TO: ALBANY PLANNING & ZONING COMMISSION
FROM: ANNE HERSCH, AICP, CITY PLANNER
SUBJECT: PA 12-045 Design Review & Parking Exception for 1117 Ordway
DATE: October 10, 2012

PROJECT: 1117 Ordway Design Review & Parking Exception FILE: PA 12-045 LOCATION: 1117 Ordway GP LU: Low Density Residential ZONING: R-1 Residential Single Family PLANNER: Anne Hersch	Original filing: August 31, 2012 Date Deemed Complete: September 7, 2012 Date of Notice Posted/Mailed: 9/28/2012 Date of Public Hearing: October 10, 2012 Total number of days to hearing: 41 days
---	---

Illustration 1. Original Building Shape with Dimensions

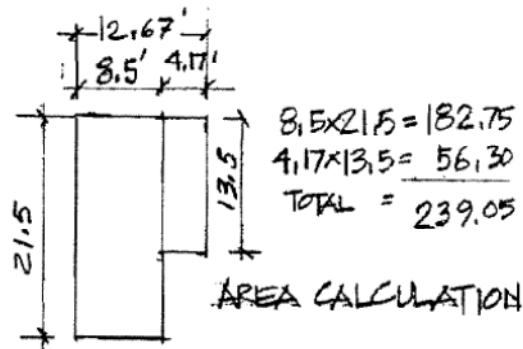
The subject property is located in the Water Course Overlay District. The Cordinices Creek is located on the south side of the property line. The Overlay District establishes an additional setback requirement of 20 ft. from the top of the natural Creek bank (Section 20.24.030 (G) (1)). Due to the setback requirements, the original structure was configured in an “L” shape 21’6” in length x 8’5” in width with a bump out of 4’1 x 13’6”.

The structure was located outside of the require Creek setback area and sited 5" from the northeast property line. Since the structure is located so close to the property line it may only be used as an accessory structure, and not a secondary residential unit. A secondary unit is required to meet the setbacks of the main structure (3.5 ft from the side yard property line). Below is an illustration from the original submittal showing the building shape and dimensions.

Original Site Plan 2011

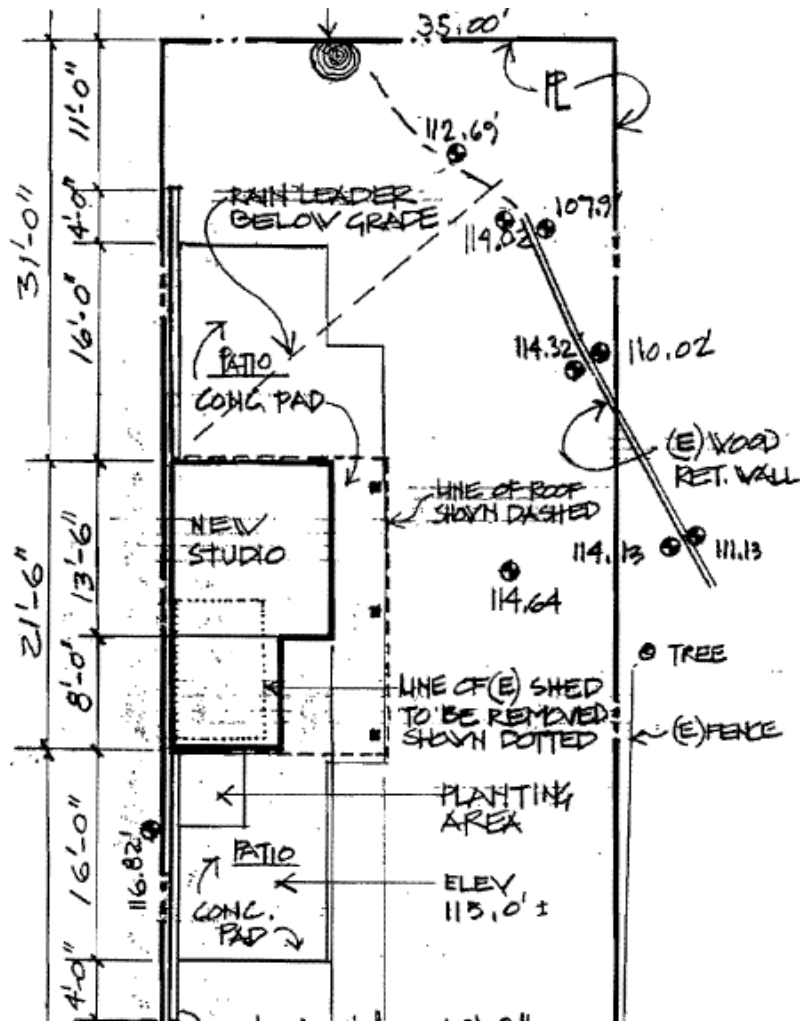
The original site plan approved in 2011 and the proposed site submitted in 2012 are shown below. The original site plan shows a total length of 53'6" on the northeast property line, from the edge of the west concrete patio pad beyond the structure and terminating at the edge of the east concrete patio. The proposed site plan shows a building length of 53'6" along the northeastern property line. Both concrete patio pads have been eliminated. The northeast wall now runs the entire 53'6" length, approximately 5" off of the property line. California Building Code requires that walls are a distance of 5 ft. or less from the property line must have a 1 hour fire rated wall. Since subsequent construction was unpermitted, it is unknown if the expanded walls are fire rated.
